SERVICE BULLETIN

M1610 2023-10-16

M1610: RECALL 0184 - 2023 CVO STREET GLIDE (FLHXSE) AND ROAD GLIDE (FLTRXSE) BRAKE LINE CLAMP

Figure 2. P-Clamp Orientation

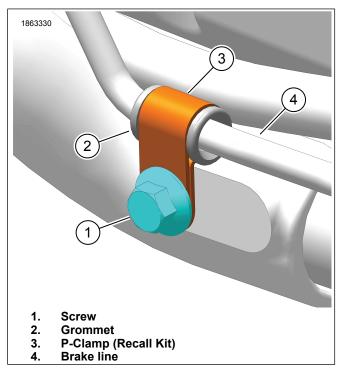
- 1. See Figure 1. Remove and retain screw (1).
- Remove and discard Original Equipment (OE) brake line clamp (2).
- See Figure 2. Install **new** P-Clamp (3) from recall kit (Part No. 91500116).
 - Make sure P-Clamp (3) is properly orientated.
- Install screw (1). Tighten.

Torque: 80-97 in-lbs (9-11 N·m)
